Access Compliance Report

Public Rights-of-Way

(Curb Ramps)

Intersection ID: 49248	Main Street: BOOMERANG_WY	Cross Street: PROSPERITY_VIEW_DR	Location: SE
ADA ID: CC0FAEED7C53	Ramp Type: BlendTrans1	Initial Pass/Fail: Pass	Overall Compliance: No
Severity Score: 0			
Codes/Mitigation Info/Possible Solution		Field Measurements/Component Compliance

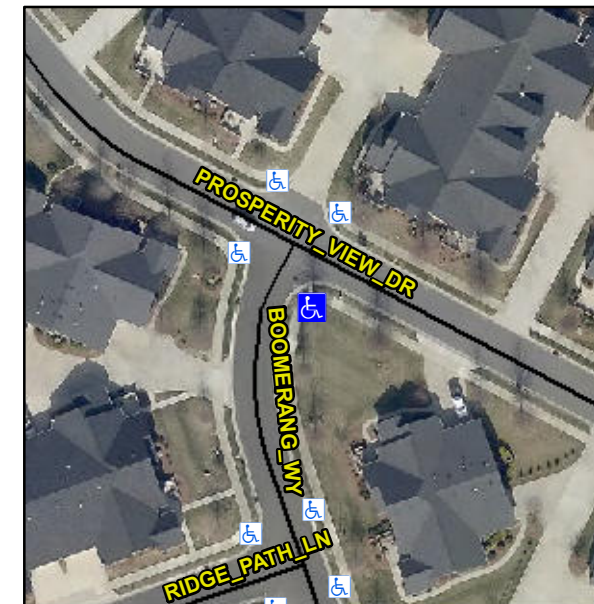
Not Found, R305.2

N/A	Ramp inside XWalk1?	N/A	N/A	Ramp inside XWalk2?	N/A
	Road Slope (%)	0.5		Clear Space?	Yes
	Road X Slope (%)	2.5	N/A	Clear Space to XWalk (in)	N/A
Yes	Any Obstructions?	No	Yes	Storm Grate/Utility Hazard?	No
	Obstruction Type			Storm Grate/Utility Type	
		N/A			N/A
			Yes	Surface Condition? (G/P)	Good
			No	Curb Slope (%)	10.3

Remove & Replace Curb Ramp With Two New Directional Ramps or Equivalent.
